Date: October 22, 2021

FROM: Route 9 Focus Group Members Maura Walsh-Copeland and John Lovegrove

SUBJECT: Citizen request for Traffic Analysis, Review and Traffic Calming for Route 9 to Route 7 North/South Routes west of Route 287.

Route 9 Safety & Operational Study

CLEAR VIEW LOOKING LEFT FROM ROUTE 718/ASHBURY CHURCH RD: 190 FT.

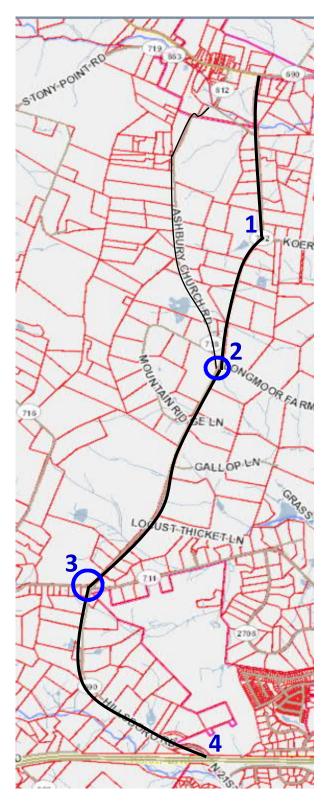
Route 718/Ashbury Church Road does not meet Code of VA, 24VAC30-73 requirements for "Intersection Sight Distance" as defined in VDOT Road Design Manual Appendix F: Access Management Design Standards for Entrances and Intersections. An interchange design will need to include traffic safety improvements, including but not limited to speed limit changes or stop signs on Rte 690. (1 comment)

CONCLUSION: Intersection does not meet required line of sight, resulting in safety impacts, to be increased by Route 7/690 interchange with expected 2,550 additional vehicles traveling at 50-60mph vs. 35 mph around blind curve. Traffic calming required. Recommendation: Small roundabout.

- 4. Route 9 to Route 7: 4 miles
 - * Allder School to Rte 7: 1.25 miles
- 1. Small (three-way) roundabout at Route 718/Ashbury Church Road (#2) would a enable traffic calming, reduce excessive speed on blind curve, and b. provide safety for turning vehicles, busses and tourists visiting Rural Economy venues.
- 2. Increased traffic with Route 690/7 Interchange will likely exceed traffic volume anticipated for Allder School Road(Rt 711)/Short Hill Road, that had small three-way roundabout installed 2017-2018.
